Final Draft August 22 2021 Summary of Wiehle Study Group (006)	2
Appendix 1 - Proffers pages 1,17-33	9
Appendix 2 - FCDOT Wiehle Ave Study Group Presentation 9.17.2020	27
FCDOT Wiehle Ave Study Group Presentation 10.15.2020	71
Appendix 3-Tammi Petrine suggestions and maps	122
Appendix 4 -Rob Walkers cross walk concept	129
Appendix 5 - Approved CDP-FDP Sheet C-7	130

Memorandum

Re: Results of the Study Group Findings

Appendix 4- Rob Walker's Road Diet and Crosswalk Concept

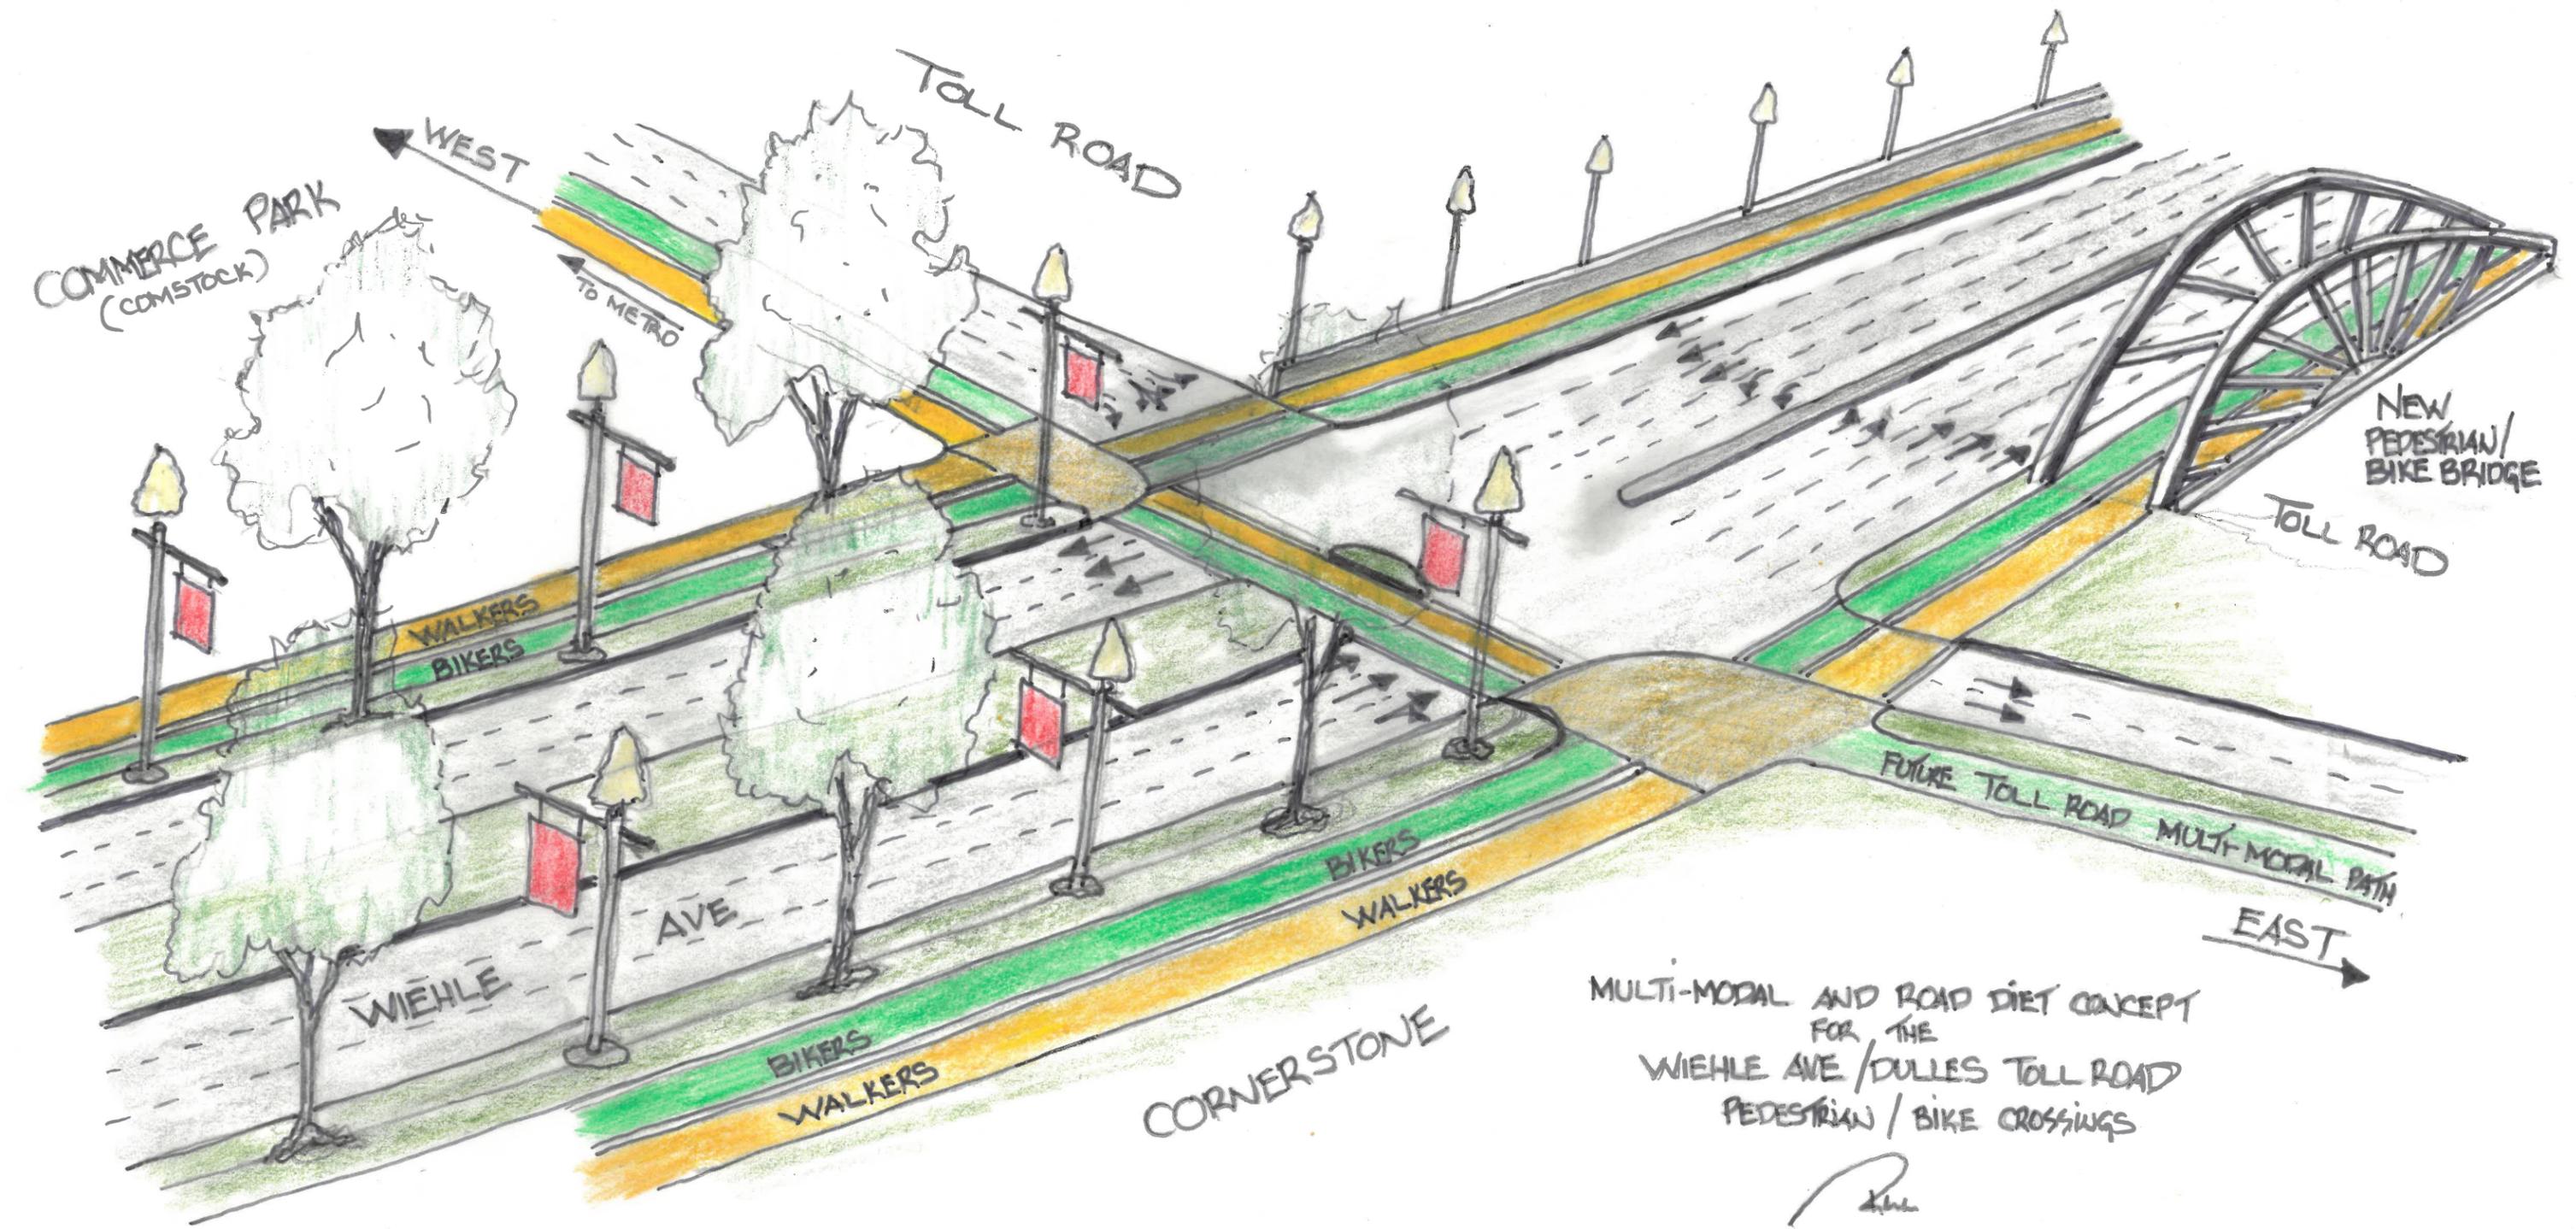
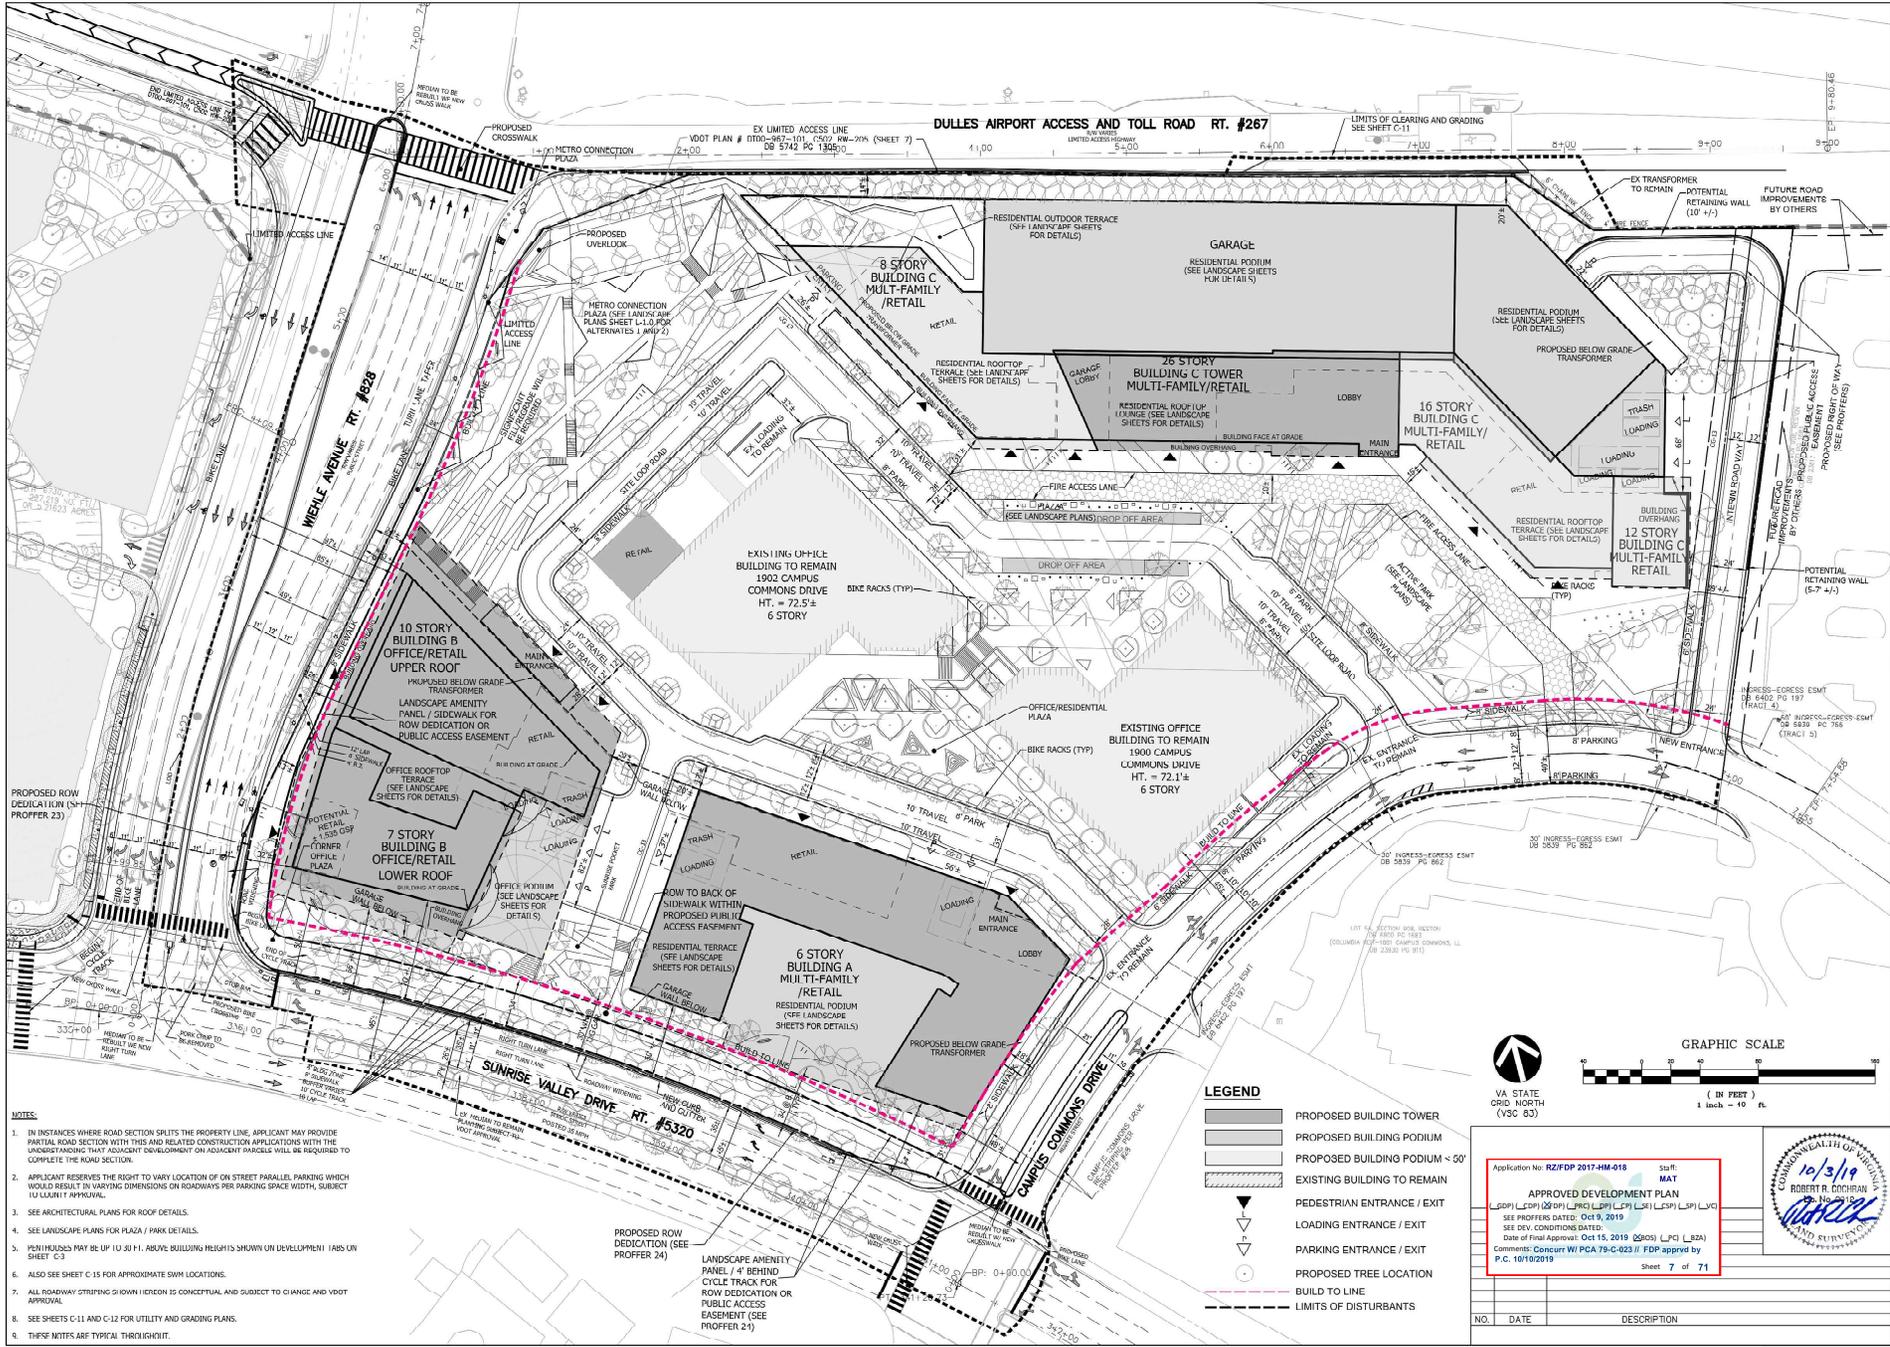
I support the vision expressed by Rob Walker's comments and his diagram of what a future Wiehle Ave might look like; a truly multimodal street that is safe for all users.

ROB WALKER (Reston resident and Chairman of the Reston P&Z Committee) – Prefers enhanced streetscapes, narrow traffic lanes, and a multimodal approach to slow traffic. He proposes the removal of the ex. free- flow vehicular movements and create safe at-grade crossings at both the Dulles Toll Road and at Sunrise Valley Drive as well as other crossings further north along Wiehle Ave. He does not believe any of the bridge options are a good idea and believes the tunnel is too expensive and would not help to address the future north /south pedestrian and bike traffic.

(See enclosed Appendix 4 for Rob’s example of an at-grade enhanced at-grade pedestrian crossing)
